***South Hills Environmental Management Consultants, LLP***

Re: On site visit by South Hills Environmental and Flathead County.

### Report on Health Advisory Follow-up

<b>System:</b>	Columbia Falls Aluminum Co.	<b>PWSID:</b>	00906
<b>Address:</b>	2000 Aluminum Drive Columbia Falls, MT 59912		
<b>Phone:</b>	892-82121 or 892-3261 for general inquires		
<b>Fax:</b>	892-5317		
<b>Contact Persons:</b>	<ol style="list-style-type: none"><li>1. Sherry Halorin - 892-8288</li><li>2. Steve Wright, P.E., Environmental Manager - 892-8211</li><li>3. Mike Davis, Casting Engineer - 892-8262; cellular 250-3895</li></ol>

Figure 3. Sanitary well seal

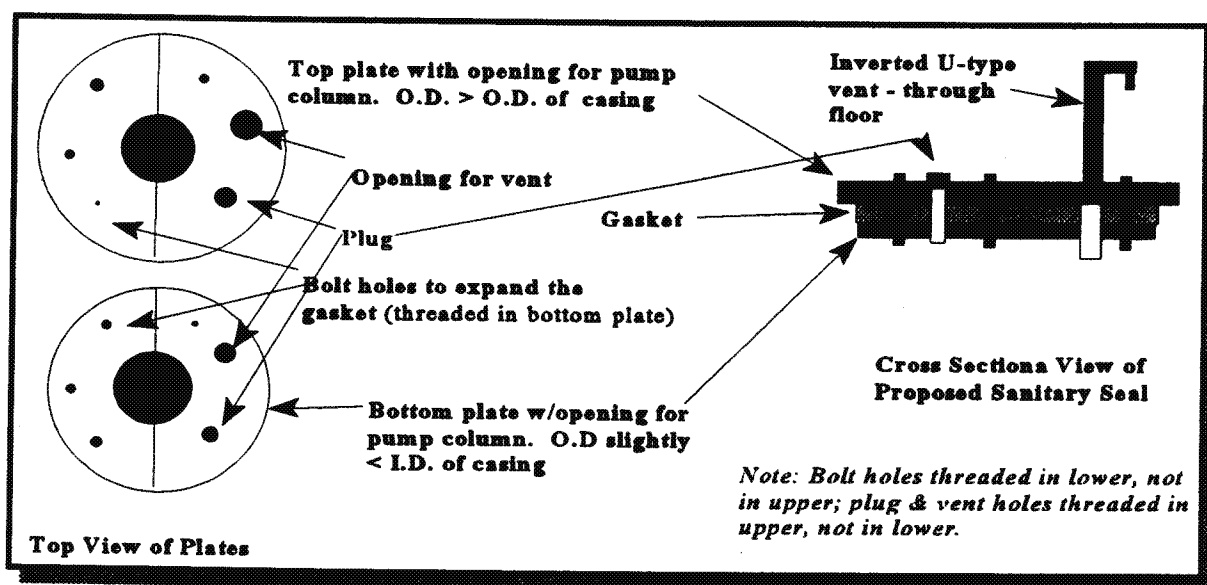
1. Seal the casings of wells number 4, 5, & 7. We suggest you do this by fabricating a sanitary well seal from metal plates with gasket material sandwiched between them. (See Fig. 3) The upper plates should be of an outside diameter slightly greater than the o.d. of the well casing and have unthreaded holes for bolts, and threaded holes for vents and plugs. The lower plates would then be slightly smaller than the i.d. of the well casing so they can fit inside the casing. The lower plates need threaded holes for the bolts and unthreaded holes for the vents and plugs. Both upper and lower plates would have to have an opening to accommodate the drop pipe and would have to be split for installation. The gasket material would be the same size as the lower plate and made of material that can expand to tightly seal all openings when the two plates are bolted together tightly.

An inverted U-type vent should be built for each sanitary seal. The vent must be screened and must extend to at least 18 inches above the upper floor in each pump house. As noted above, each sanitary seal should have a threaded plug which can be removed for introduction of chlorine solution or for measuring water levels.
2. A vent must be fabricated for well number 6 too. We suggest that you consider replacing the existing welded seal with one similar to the fabricated sanitary seals described in number 1 above.
3. The power shaft's seal should be tightened or replaced so that water cannot leak out (or in).
4. We suggest that you consider switching to water lubricated line shafts in all wells. The addition of organic vegetable oils may be providing a food source and, thus, contributing to
